**SUNDRY NOTICES AND REPORTS ON WELLS**

8. Well Name and No.  
**Brennan Fed. Com #2**

9. API Well No.  
**30-041-20922**

**Brennan Fed Com 2  
Manzano, LLC  
January 30, 2019  
Conditions of Approval**

Manzano, LLC  
Brennan Fed. Com #2  
API 30-041-20922  
WBD After P&A

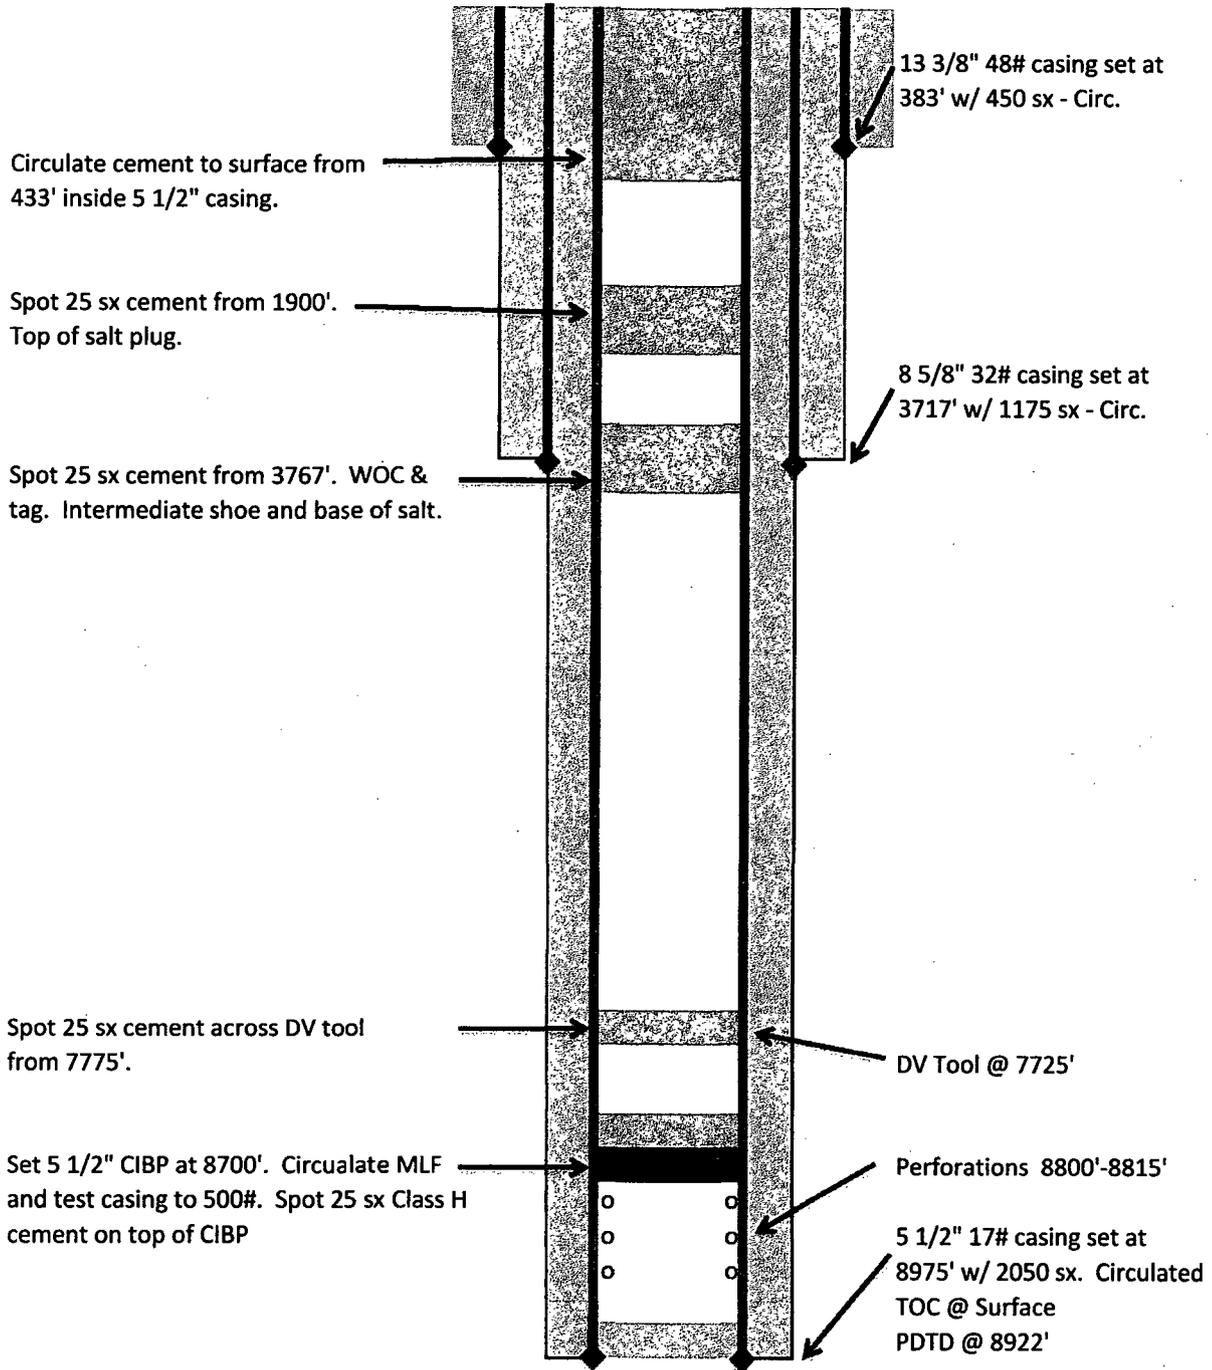
1. Operator shall place CIBP at 8,700' (50'-100' above top most perf) and place 25 sx of Class H cement on top as proposed. WOC and TAG.
2. Operator shall place a balanced Class H cement plug from 7,775'-7,600' to seal the DV tool and top of the Wolfcamp Formation.
3. Operator shall place a balanced Class C cement plug from 6,900'-6,730' to seal the top of the Abo Formation.
4. Operator shall place a balanced Class C cement plug from 5,500'-5,345' for the purpose of a spacer plug as no more than 3,000' is allowed between plugs.
5. Operator shall place 25sx Class C cement at 3,767' as proposed to seal the 8-5/8" shoe. WOC and TAG. Tag must be a minimum of 3,667'.
6. Operator shall place a balanced Class C cement plug from 2,200'-2080' to seal the Yates formation. WOC and TAG.
7. Operator shall place a balanced Class C cement plug from 1,950'-1,700' to seal the Salt formation. WOC and TAG.

Note: Operator may combine plugs 6 and 7.

8. Operator shall place a balanced Class C cement plug from 433'- surface to isolate the 13-3/8" shoe.
9. See Attached for general plugging stipulations.
